Access Compliance Report

Public Rights-of-Way

(Curb Ramps)

Intersection ID: 48572	Main Street: MATLEA_CT	Cross Street: SALAMANDER_RUN_LN	Location: NW
ADA ID: B0FFE5CA37E0	Ramp Type: BlendTrans1	Initial Pass/Fail: Pass	Overall Compliance: No
Severity Score: 0			
Codes/Mitigation Info/Possible Solution		Field Measurements/Component Compliance

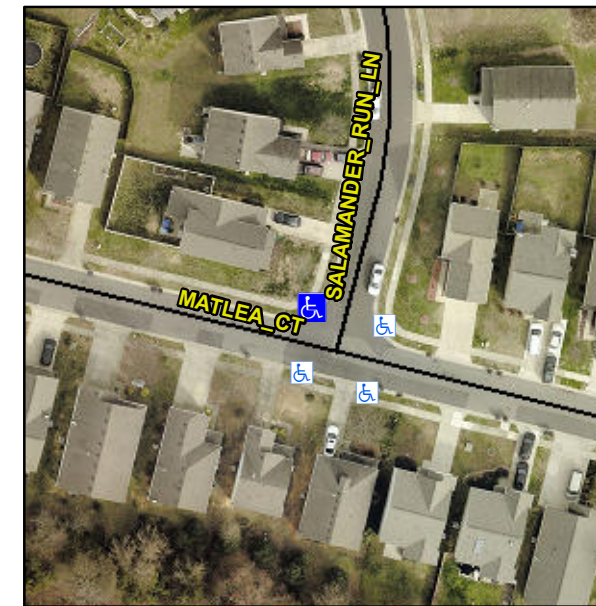
Not Found, R304.2.2-Perp, R304.3.2-Para, R302.7

Compliance	Description	Data	Compliance	Description	Data
N/A	Ramp Length (in)	50.0	Yes	BlendTrans Slope (%)	4.6
Yes	Ramp Width (in)	48.0	Yes	BlendTrans XSlope (%)	0.2
N/A	Flare Type LT	Sloped	N/A	Flare Type RT	Sloped
N/A	Flare Slope LT (%)	1.3	N/A	Flare Slope RT (%)	1.0
N/A	Flare Traversable LT?	No	N/A	Flare Traversable RT?	No
Yes	Landing Length (in)	49.0	Yes	DWS Provided?	Yes
Yes	Landing Width (in)	65.5	Yes	DWS Contrast?	Yes
No	Landing Slope (%)	2.2	Yes	DWS Length (in)	24.0
Yes	Landing X Slope (%)	1.5	Yes	DWS Full Width?	Yes
N/A	Landing Curb? (Y/N)	No	Yes	DWS Offset (in)	2.0
N/A	Shared Landing?	No			
No	Gutter Ponding?	Yes	Yes	Gutter Slope (%)	3.8
Yes	Gutter Lip Ht (in)	0.0	Yes	Gutter X Slope (%)	1.2
N/A	Painted X Walk1?	No	N/A	Painted X Walk2?	No
	X Walk 1 Direction	To S		X Walk 2 Direction	To E
	X Walk 1 Width (in)	N/A		X Walk 2 Width (in)	N/A
	X Walk 1 Slope (%)	4.4		X Walk 2 Slope (%)	3.6
	X Walk 1 X Slope (%)	3.3		X Walk 2 X Slope (%)	1.9

N/A	Ramp inside XWalk1?	N/A	N/A	Ramp inside XWalk2?	N/A
	Road Slope (%)	2.3		Clear Space?	Yes
	Road X Slope (%)	6.2	N/A	Clear Space to XWalk (in)	N/A
Yes	Any Obstructions?	No	Yes	Storm Grate/Utility Hazard?	No
	Obstruction Type			Storm Grate/Utility Type	
		N/A			N/A
			Yes	Surface Condition? (G/P)	Good
			No	Curb Slope (%)	9.8

Remove & Replace Curb Ramp With Two New Directional Ramps or Equivalent.
